RE: **Lot 3 Block 8 Volcano Cliffs Unit 22 SAD 228
6420 Canavio Rd. NW
Grading and Drainage Plan
Engineers Stamp Date 5/12/2020 (D10D003E3)**

Based upon the information provided in your submittal received 6/17/2020, this plan is approved for Grading Permit.

VOLCANO CLIFFS
6420 CANAVIO RD NW
PULTE ID 18

GRADING AND DRAINAGE PLAN

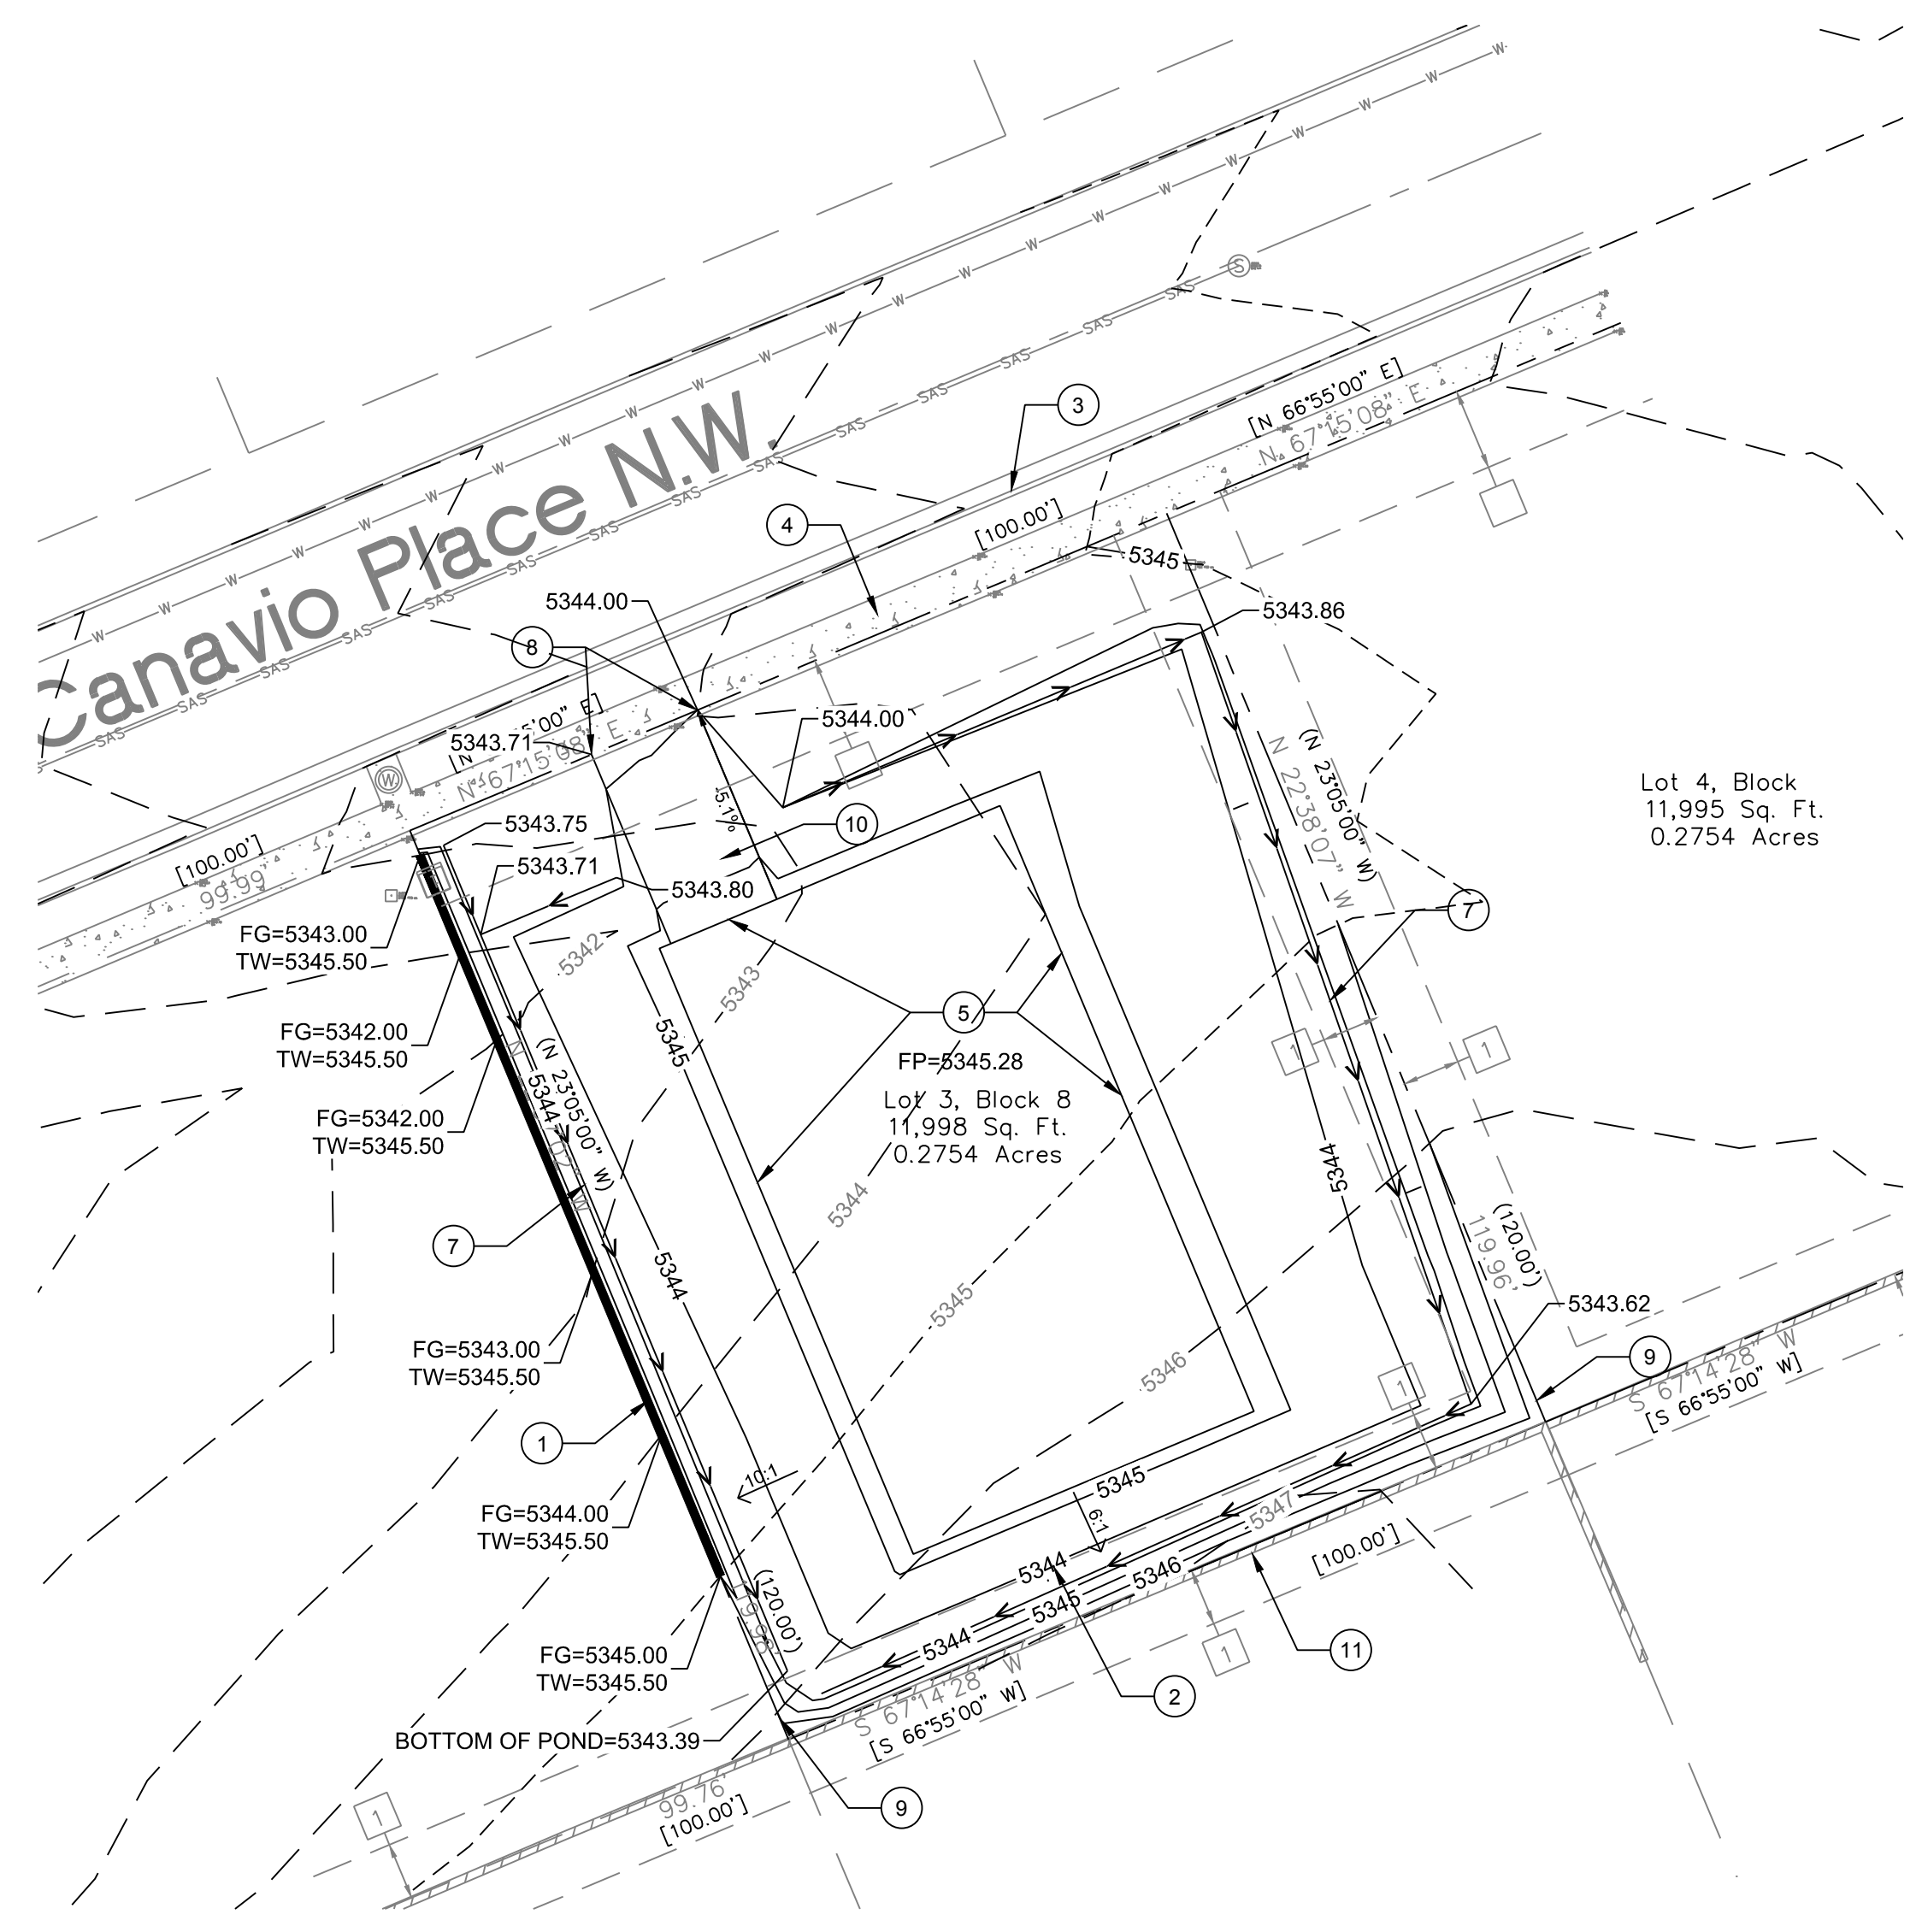
Prior to Building permit approval a Pad Certification will be required, provided by the Engineer or a registered Land Surveyor.

Reiterate to the Owner/Contractor that a separate permit for a garden/retaining wall must be obtained with the approved G&D plan and Pad Certification. **Also, if a swimming pool is to be placed the grading and drainage plan will change and will need to be resubmitted.**

Prior to Certificate of Occupancy release, Engineer Certification per the DPM checklist will be required.
